Access Compliance Report

Public Rights-of-Way

(Curb Ramps)

Intersection ID: 4511	Main Street: FRANK_VANCE_RD	Cross Street: PEPPER_ANN_LN	Location: SW
ADA ID: F70E5D7AF624	Ramp Type: Perp	Initial Pass/Fail: Pass	Overall Compliance: No
		Severity Score: 10

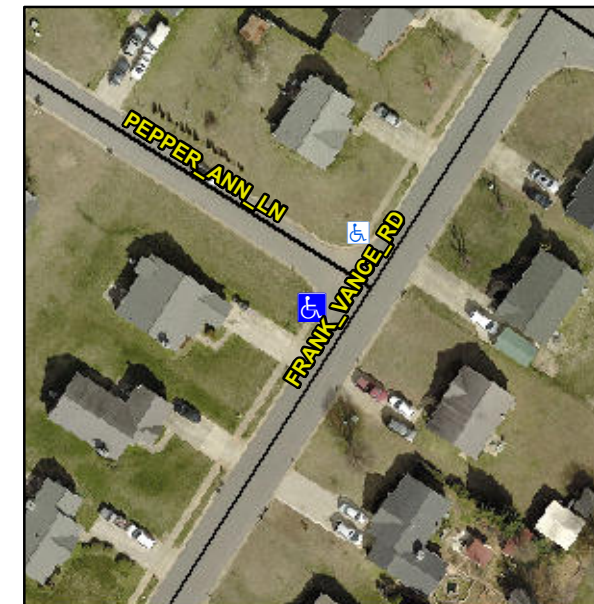
Not Found, R304.2.1, R304.2.2-Perp, R304.3.2-Para, R304.5.3, R305.2

Remove & Replace Entire Ramp.
